Subject: Duke Energy Corporation
McGuire Nuclear Station, Units 1 and 2
Docket Numbers 50-369 and 50-370
Catawba Nuclear Station, Units 1 and 2
Docket Numbers 50-413, 50-414
Proposed Technical Specifications and Bases
Amendment
2.0, Safety Limits; 3.3, Instrumentation; 3.4,
Reactor Coolant System; 5.6, Reporting
Requirements

In accordance with the provisions of 10CFR50.90, Duke Energy Corporation (Duke) proposes to revise the McGuire and Catawba Nuclear Station Facility Operating Licenses and Technical Specifications (TS) and Bases. The proposed amendment reduces the required minimum measured Reactor Coolant System (RCS) flow rate from 390,000 gallons per minute (gpm) to 382,000 gpm for McGuire and Catawba Units 1 and 2. Additionally, the proposed change relocates RCS related cycle-specific parameter limits from the TS to, and thus expands, the Core Operating Limits Reports (COLR) for the McGuire and Catawba Nuclear Stations. These proposed changes will allow Duke the flexibility of enhancing operating and core design margins without the need for cycle-specific license amendment requests.

McGUIRE UNITS 1 AND 2 TECHNICAL SPECIFICATIONS
AND
TECHNICAL SPECIFICATION BASES

MARKED COP

Figure 2.1.1-1

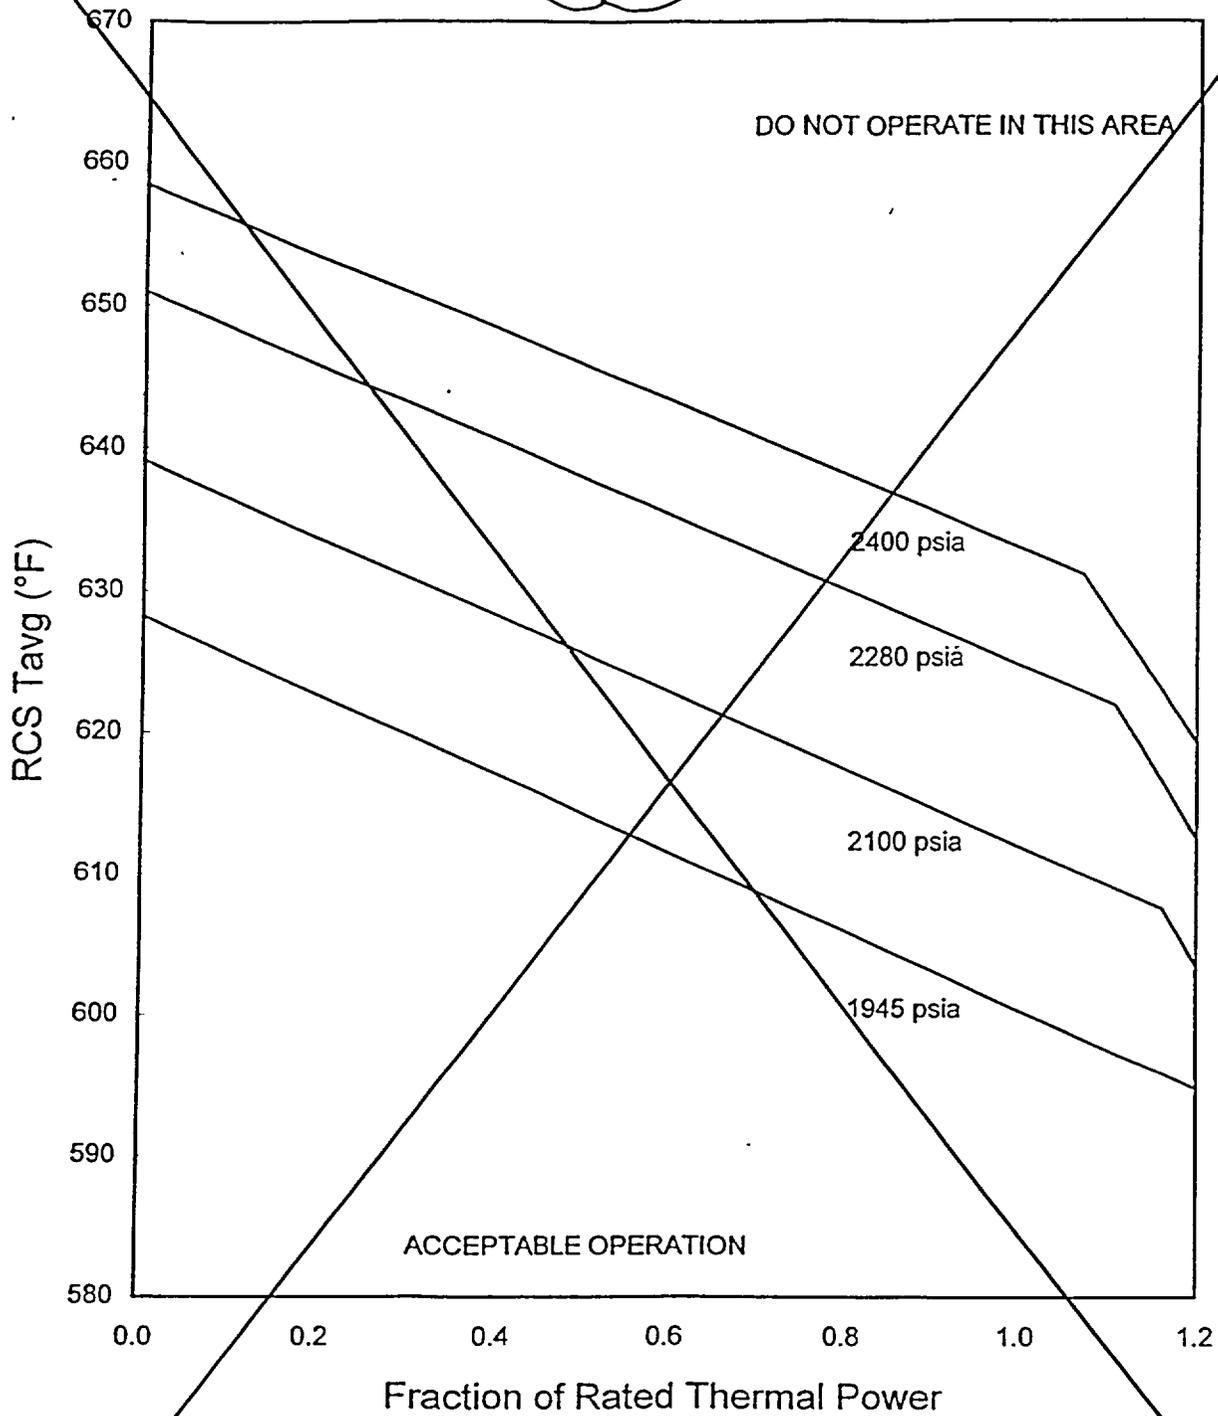
In MODES 1 and 2, the combination of THERMAL POWER, Reactor Coolant System (RCS) highest loop average temperature, and pressurizer pressure shall not exceed the ~~SLs~~ ^{LIMITS} specified in ~~Figure 2.1.1 for four loop operation.~~ ^{INSERT 1}

DELETE

The proposed amendment also relocates TS Figure 2.1.1-1, "Reactor Core Safety Limits," to the COLRs, replacing it with fuel integrity limits (95/95 DNB and 95/95 CFM

INSERT 1

the COLR for four loop operation; and the following SLs shall not be exceeded:

- 2.1.1.1 The departure from nucleate boiling ratio (DNBR) shall be maintained \geq the 95/95 DNB criterion for the DNB correlation(s) specified in the thermal-hydraulic analytic method(s) listed in Section 5.6.5(b).
- 2.1.1.2 The peak fuel centerline temperature shall be maintained \leq the 95/95 CFM criterion for the fuel design(s) specified in the fuel mechanical analytic method(s) listed in Section 5.6.5(b).

Figure B 2.1.1-1

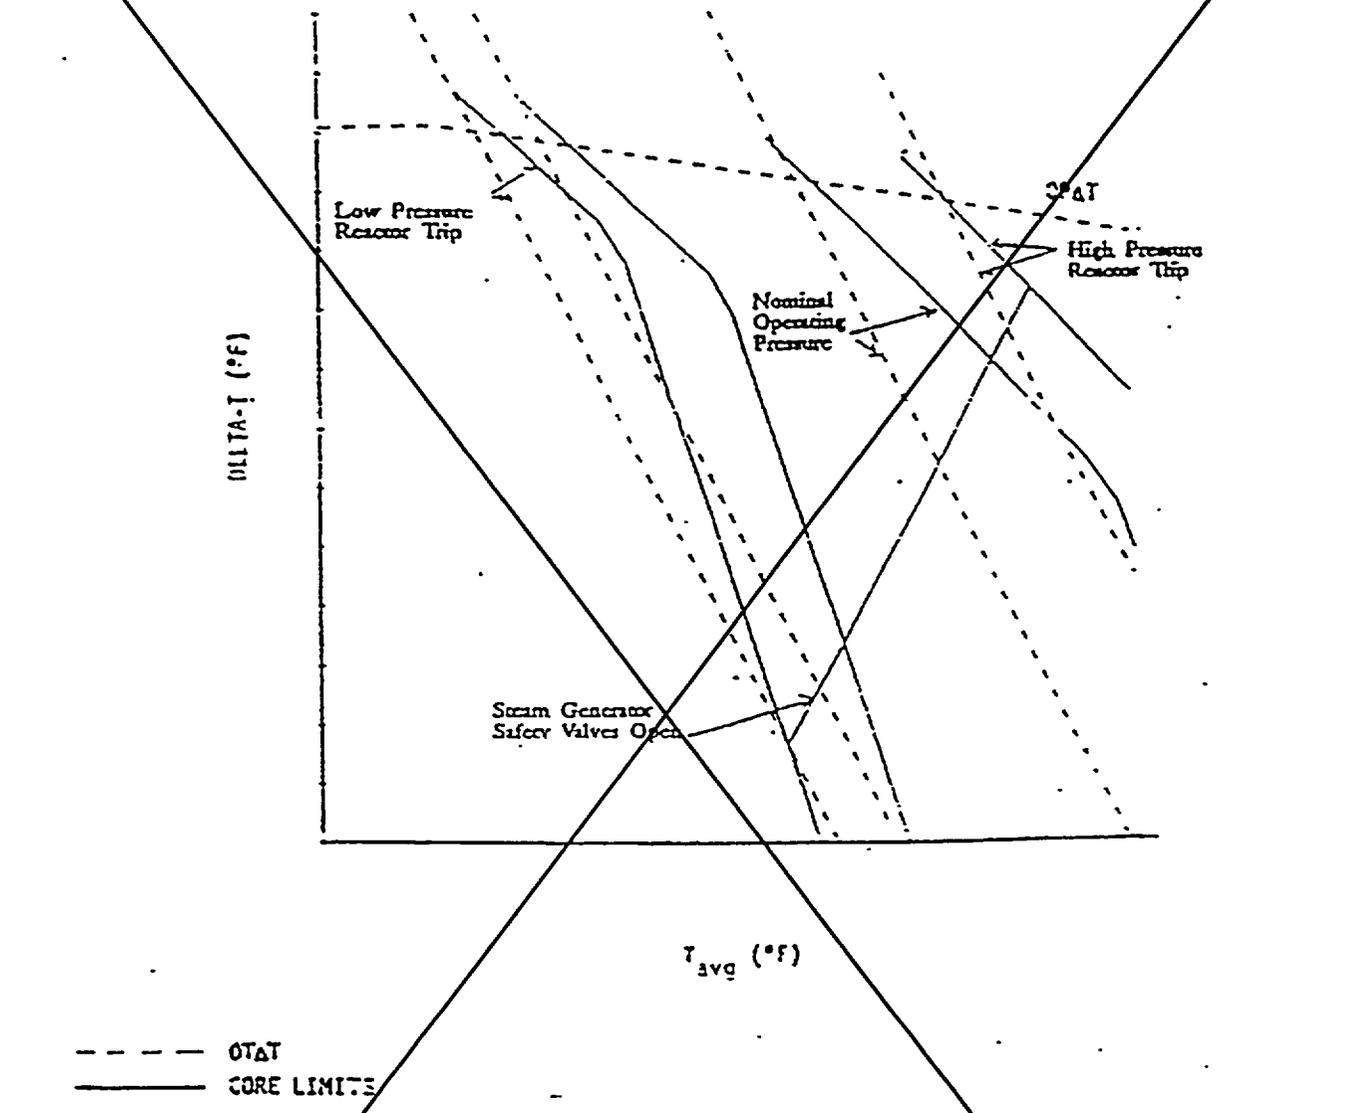
The curves provided in Figure B 2.1.1-1 show the loci of points of RCS Pressure, and average temperature for which the minimum DNBR is not less than the safety analyses limit, that fuel centerline temperature remains below melting, that the average enthalpy in the hot leg is less than or equal to the enthalpy of saturated liquid, and that the exit quality is within the limits defined by the DNBR correlation.

The curves in Figure 2.1.1-1 are based on a reference nuclear enthalpy rise hot channel factor (F_{DH}), a reference axial power shape ($F_z/x/L$), the approved CHF correlation and the Technical Specification minimum flow rate. Therefore, these curves provide limits for which the analyses analyzed at the above reference values will be bounded. The curves in Figure B 2.1.1-1 illustrate the various RFS functions that are designed to prevent the unit from reaching the limit.

DELETE

INSERT 2

The reactor core SLs are established to preclude violation of the following fuel design criteria:

Figure 2.1.1-1
Reactor Core Safety Limits
Four Loops in Operation

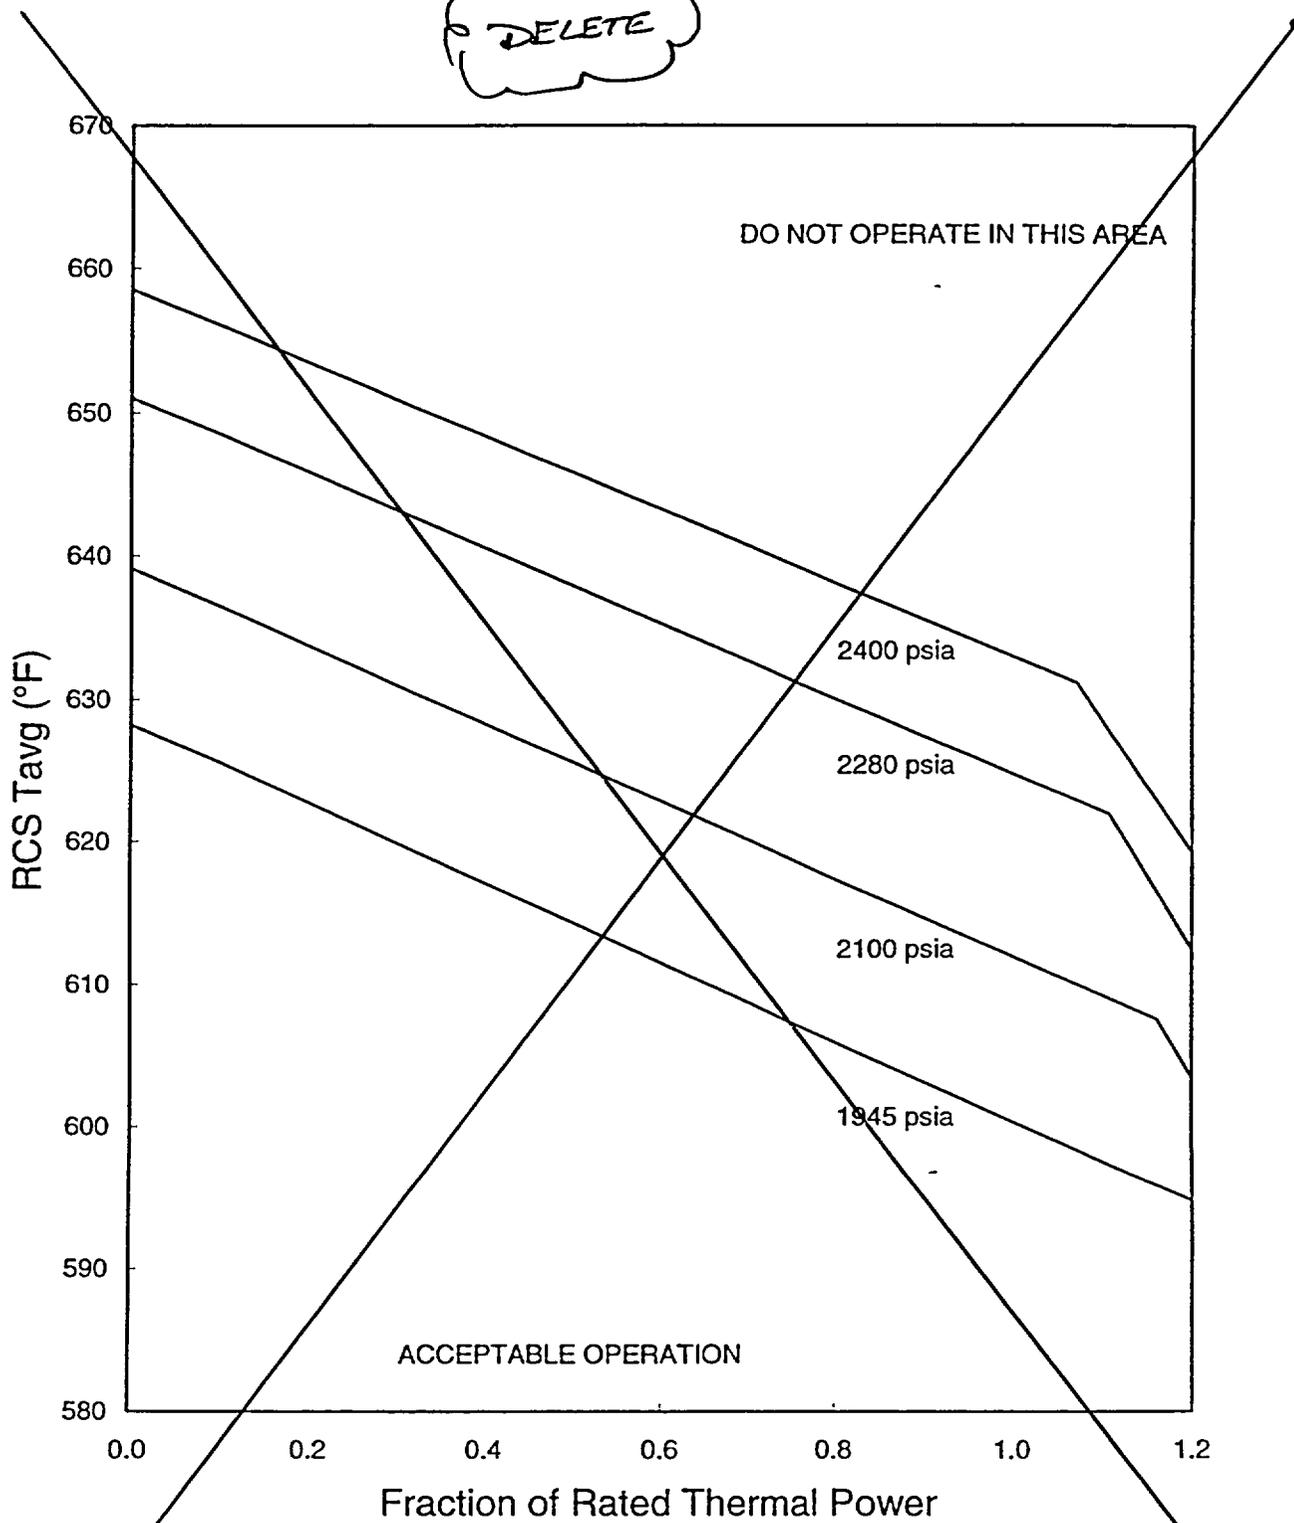
In MODES 1 and 2, the combination of THERMAL POWER, Reactor Coolant System (RCS) highest loop average temperature, and pressurizer pressure shall not exceed the SLs specified in Figure 2.1.1.1 for four loop operation.

DELETE

INSERT 1

the COLR for four loop operation; and the following SLs shall not be exceeded:

- 2.1.1.1 The departure from nucleate boiling ratio (DNBR) shall be maintained \geq the 95/95 DNB criterion for the DNB correlation(s) specified in the thermal-hydraulic analytic method(s) listed in Section 5.6.5(b).
- 2.1.1.2 The peak fuel centerline temperature shall be maintained \leq the 95/95 CFM criterion for the fuel design(s) specified in the fuel mechanical analytic method(s) listed in Section 5.6.5(b).

Figure B 2.1.1-1
Illustration of Overtemperature
and Overpower ΔT Protection

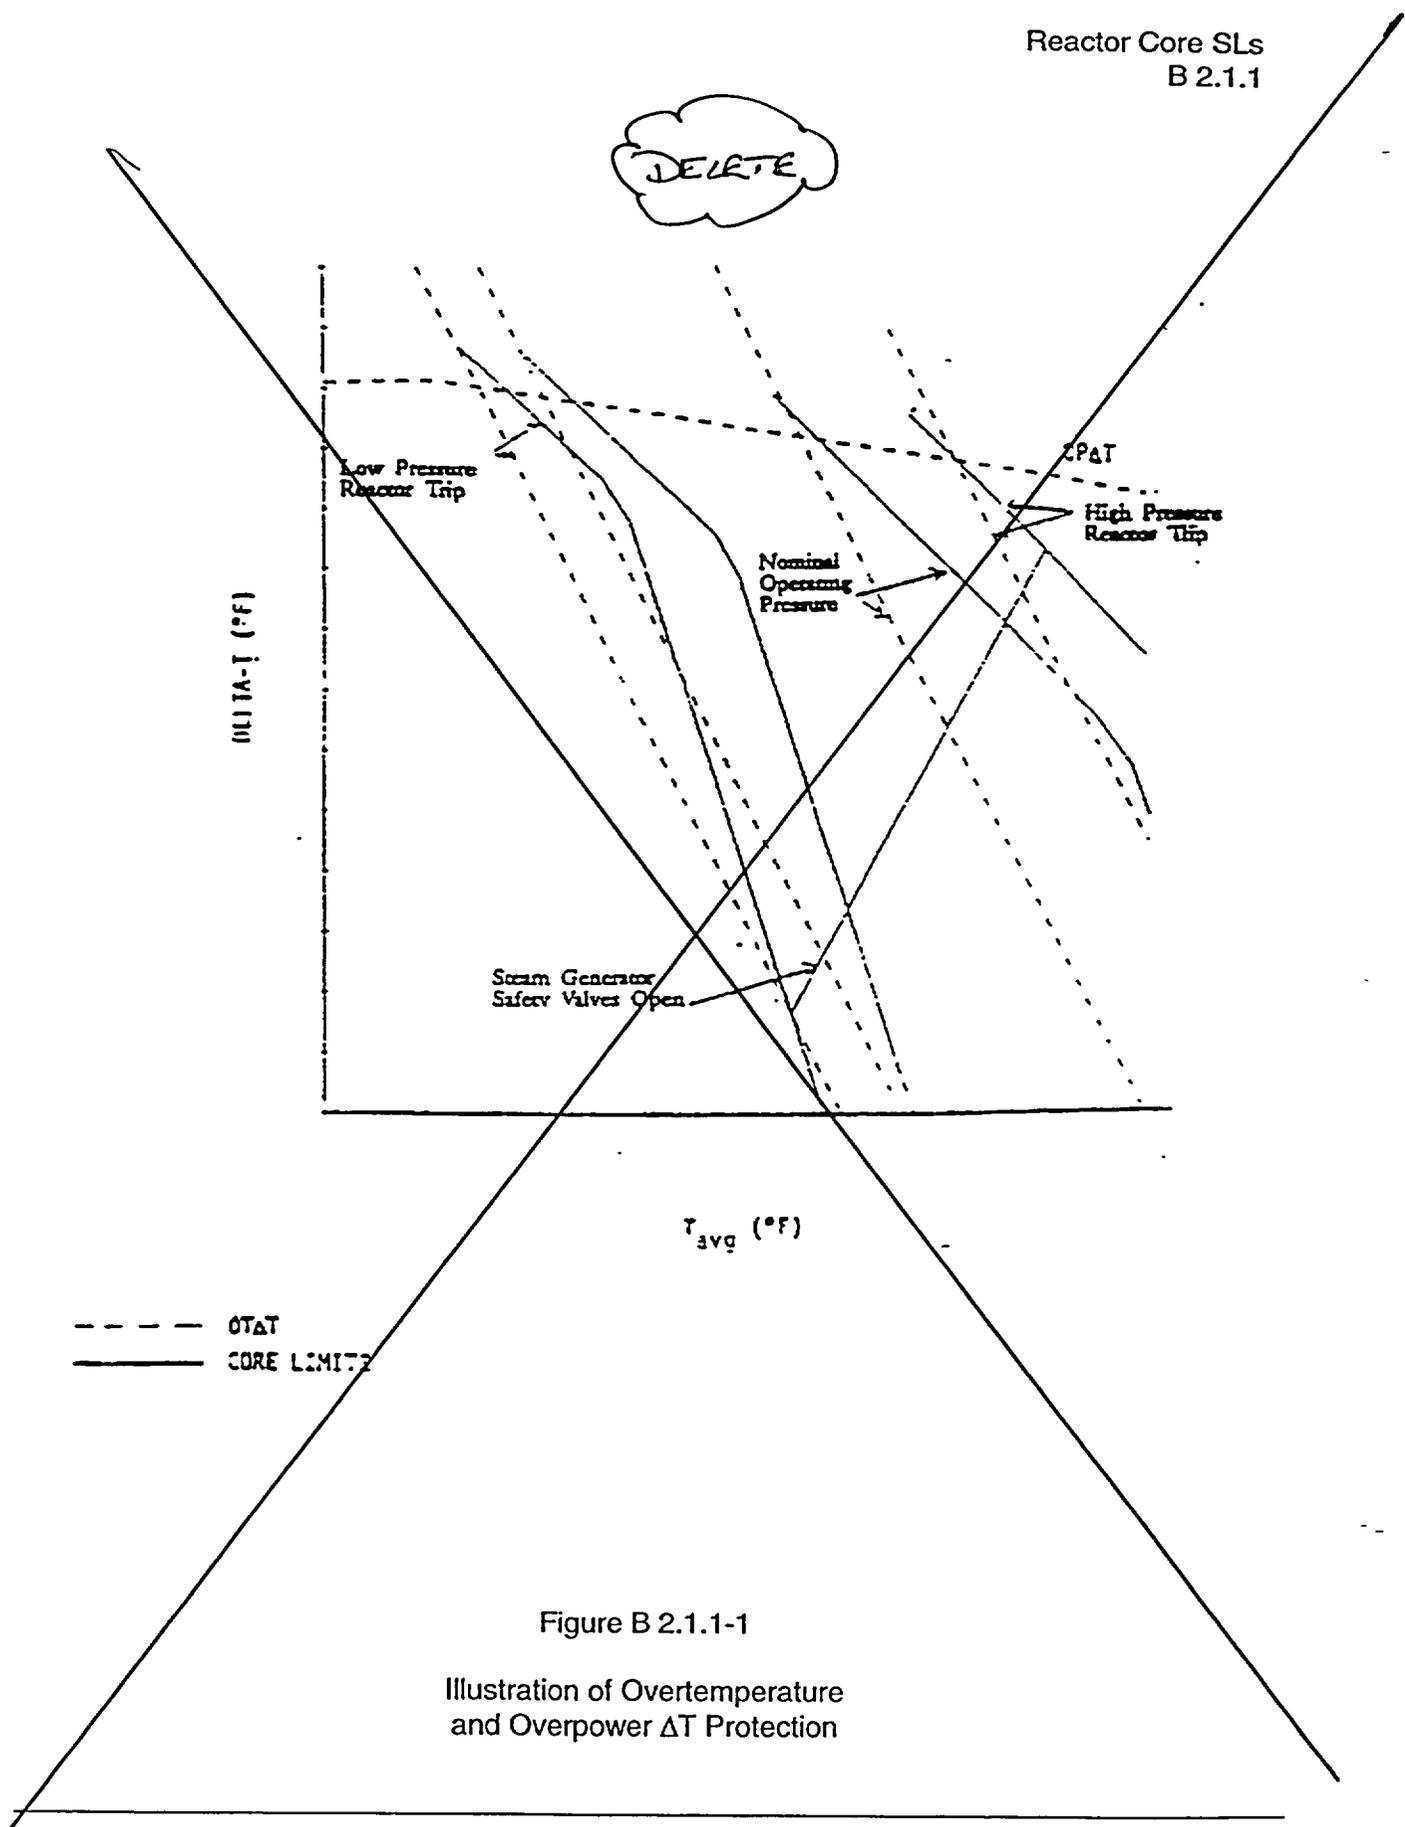
The ~~curves~~ provided in ~~Figure B.2.1.1-1~~ show the loci of points of ~~CHF~~, RCS Pressure, and average temperature for which the minimum DNBR is not less than the safety analyses limit, that fuel centerline temperature remains below melting, that the average enthalpy in the hot leg is less than or equal to the enthalpy of saturated liquid, and that the exit quality is within the limits defined by the DNBR correlation.

~~The curves in Figure 2.1.1-1 are based on a reference nuclear enthalpy rise hot channel factor (F_{CH}), a reference axial power shape ($F_z/x/L$), the approved CHF correlation and the Technical Specification minimum flow rate. Therefore, these curves provide limits for which the analyses analyzed at the above reference values will be bounded. The curves in Figure B 2.1.1-1 illustrate the various RPS functions that are designed to prevent the unit from reaching the limit.~~

DELETE

INSERT 2

The reactor core SLs are established to preclude violation of the following fuel design criteria:
